ORIGINATION FORM

Proposed Revisions to a Standard Plans Index

Index Number: 700-010

Index Title: Single Column Ground Signs

GUIDE TO USE THIS INDEX

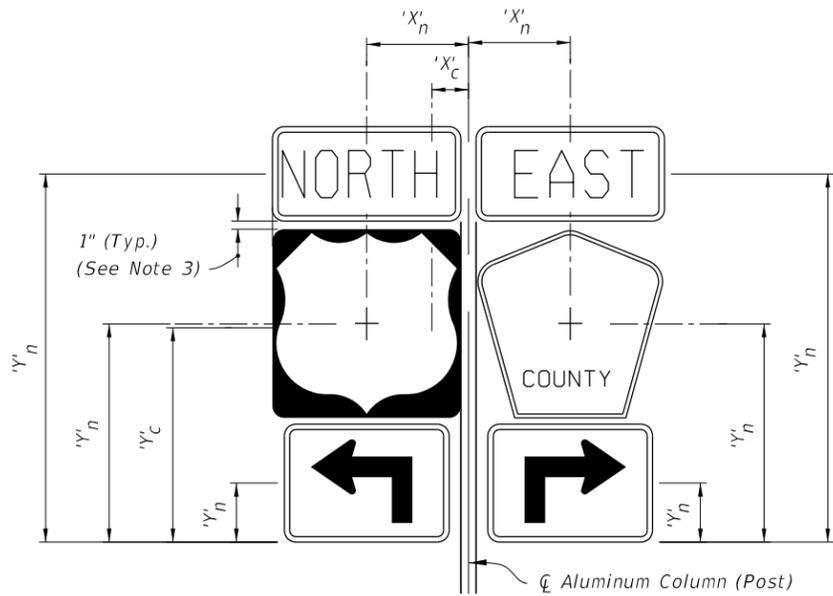
Sheet 1: Added New Note 1 - "Meet the requirements of Specification 700"; Delete General Notes 2 through 7; Renumber General Notes.

ADDED NEW NOTE 1:

STEP 2: Determine the height 'H' from groundline to the centroid of the individual sign or sign cluster. Meet the requirements of Specification 700.

GENERAL COMMENT: Material information was deleted. Information is either already covered in Standard Specifications OR will be added to Section 700, 962 or 965 in conjunction with these revisions.

DELETED

1. Meet the requirements of Specification 700.
2. Shop Drawings:
This Index is considered fully detailed. Submit Shop Drawings only for minor modifications not detailed in the Plans.
3. BREAKAWAY SUPPORTS REQUIREMENTS: Install non-frangible aluminum column (post) (larger than 3½") with breakaway supports as shown on Sheet 4. Signs shielded by barrier wall or guardrail do not require breakaway support.

SHEET 4 of 11

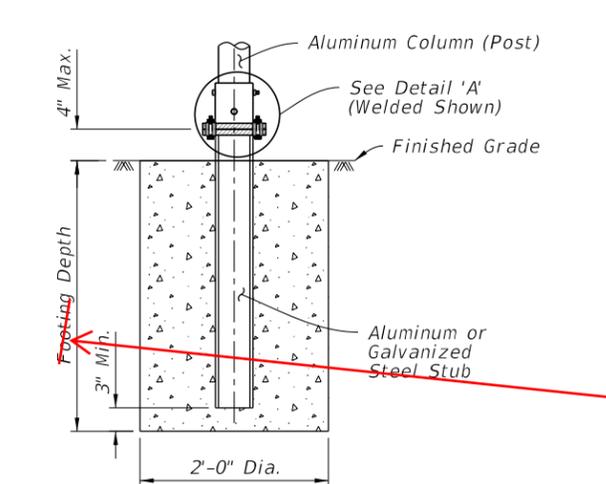
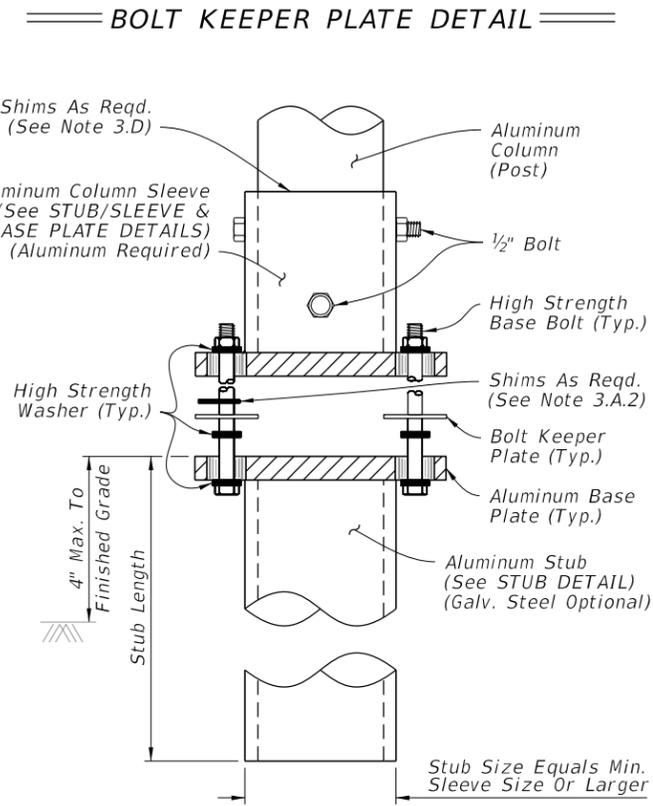
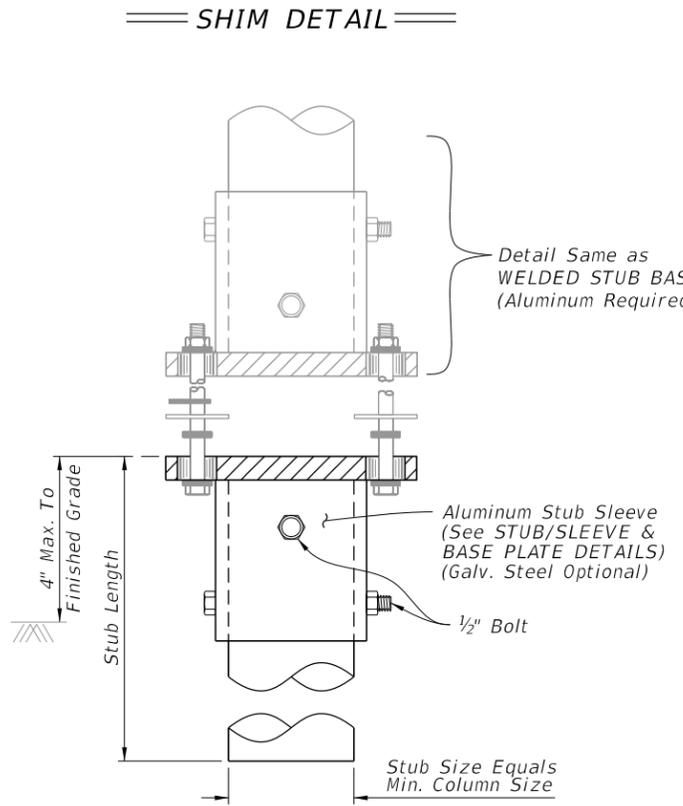
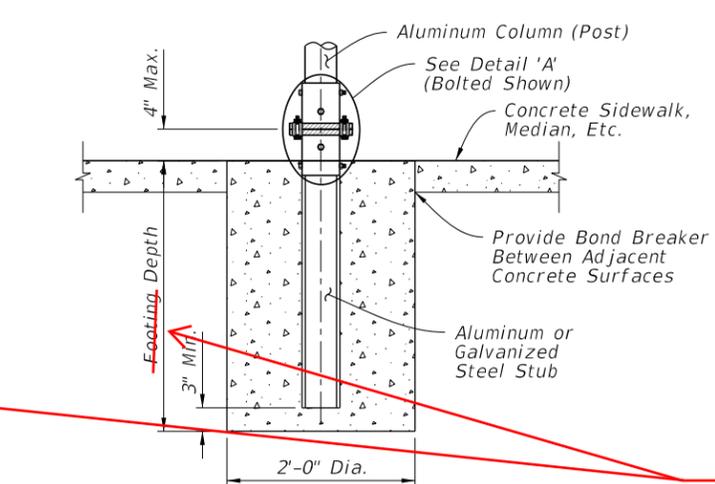
Sheet 4: Updated Note 1.A. - Deleted Concrete Class; See FOUNDATION TABLE on Sheet 3 for foundation embedment depth and stub length.

- NOTES:**
- Foundation Notes for Slip Base:
 - ~~Place Stub into concrete foundation given in the FOUNDATION TABLE using Class II Concrete.~~
 - Slip Base Fabrication Notes:

UPDATED NOTE:
See FOUNDATION TABLE on Sheet 3 for foundation embedment depth and stub length.

- Foundation Notes for Slip Base:**
 - See FOUNDATION TABLE on Sheet 3 for foundation embedment depth and stub length.
- Slip Base Fabrication Notes:**
 - The difference between the O.D. of the post and I.D. of the Sleeve must be 1/16" or less.

BACK-TO-BACK SIGN DETAIL

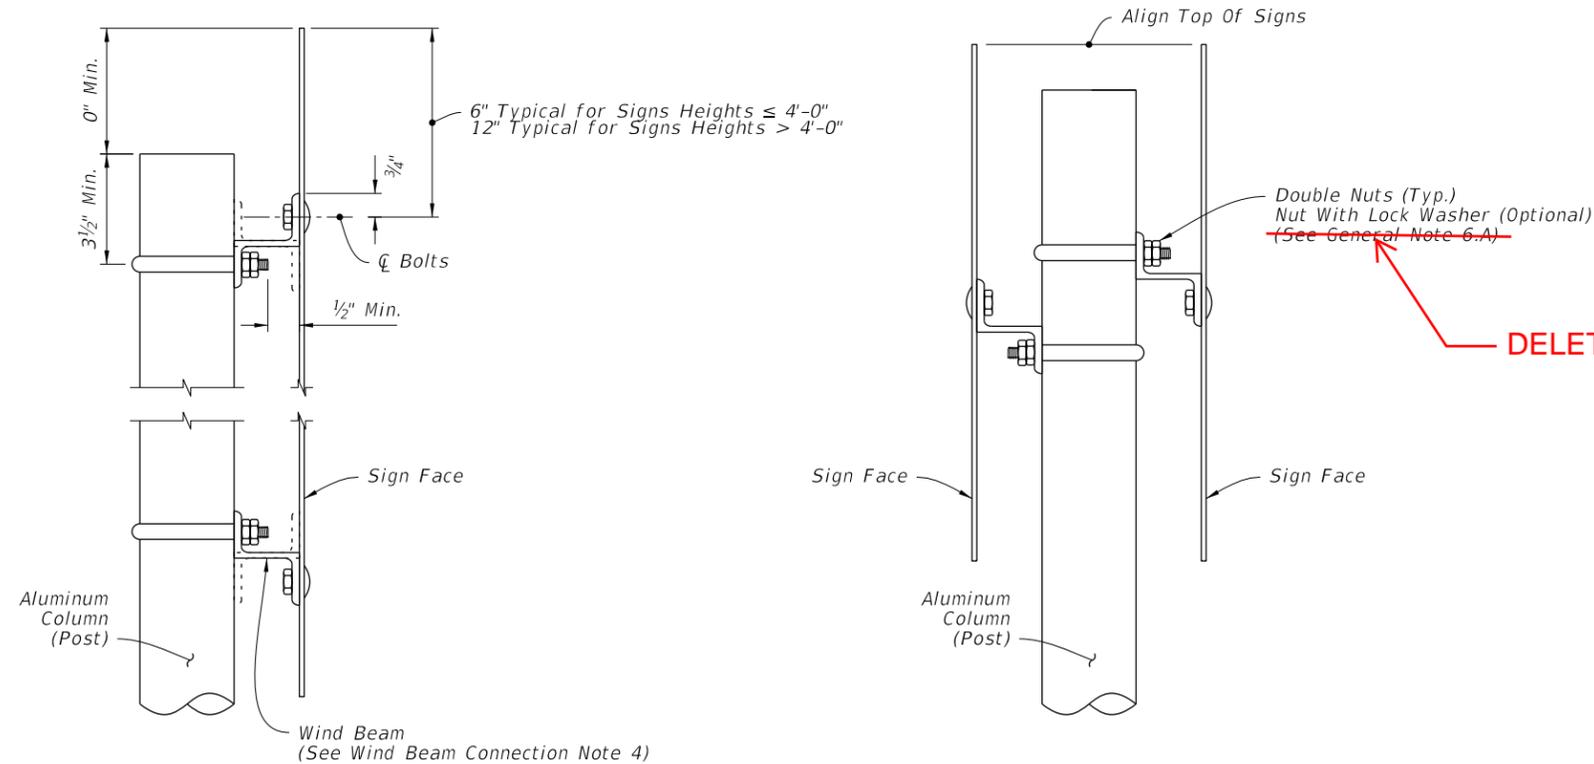
Sheet 6: Deleted General Note reference in the BACK-TO-BACK SIGN DETAIL.

SIGN PANEL SIDE VIEW

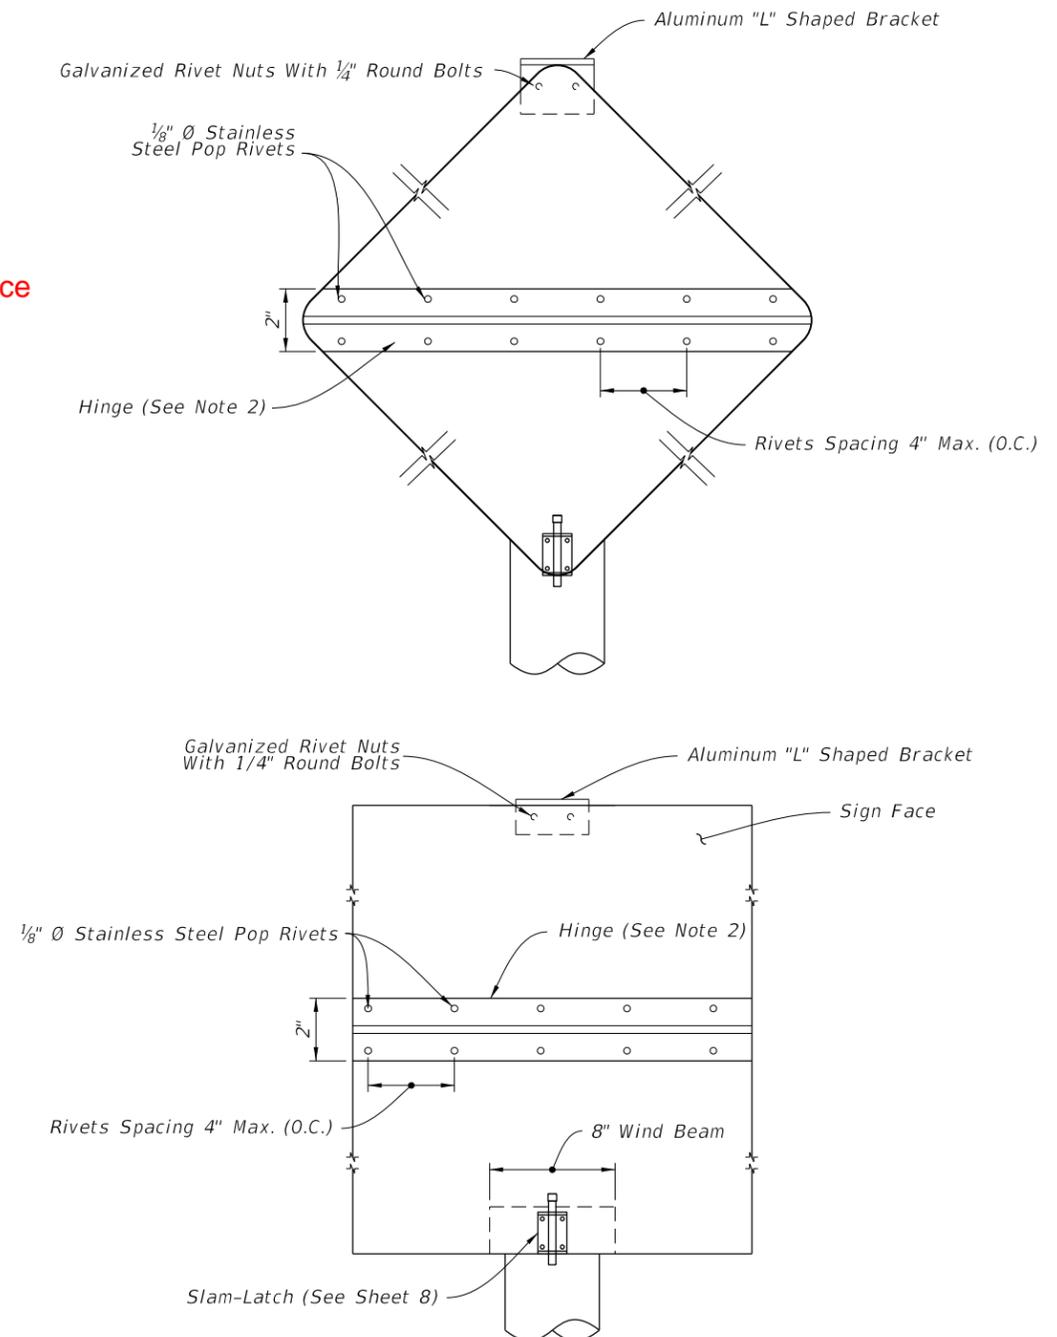
Sheet 7: Deleted General Note references in the SIGN PANEL SIDE VIEW details.

DETAIL "B"

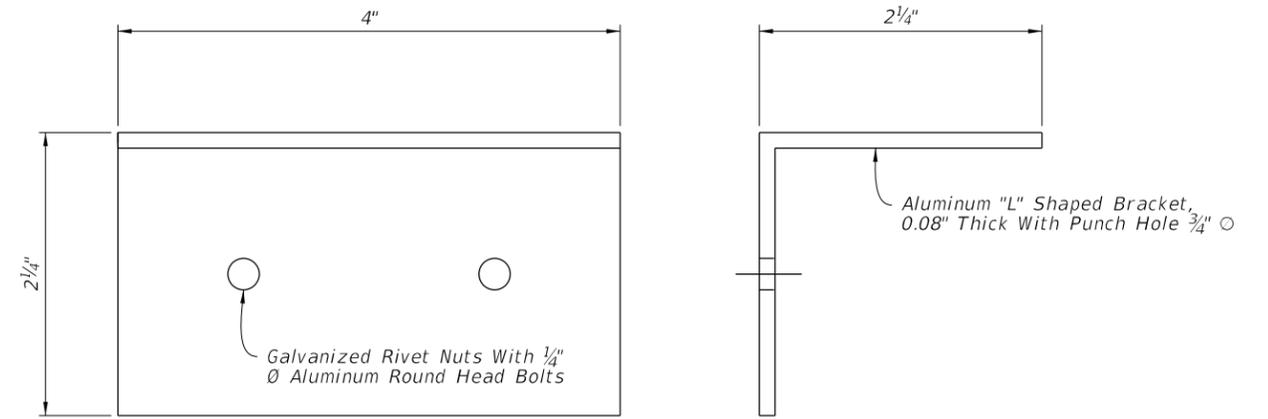
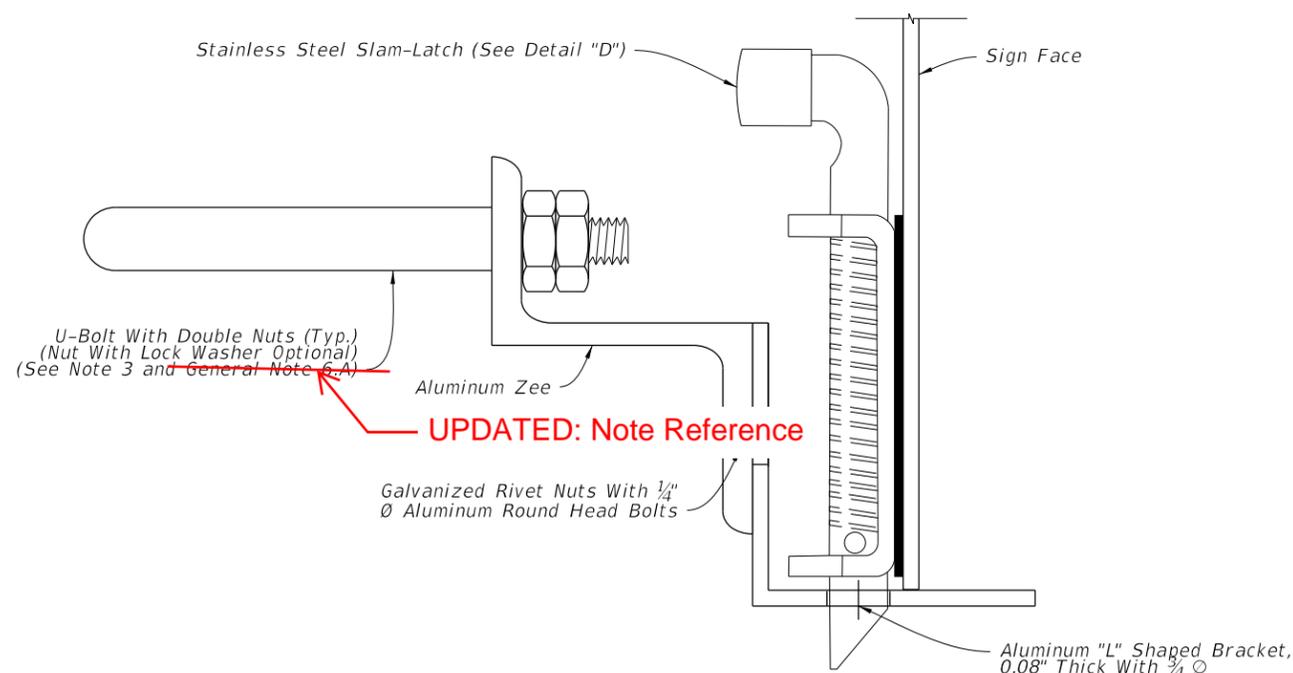
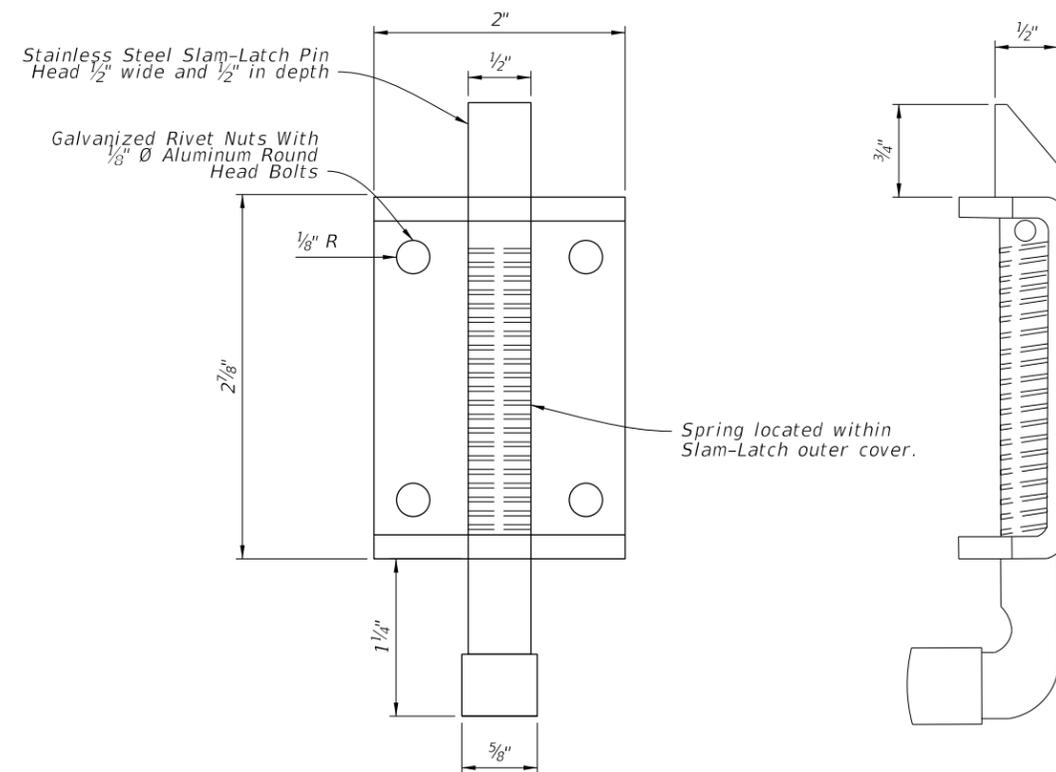
Sheet 8: Deleted General Note reference in Detail"B".
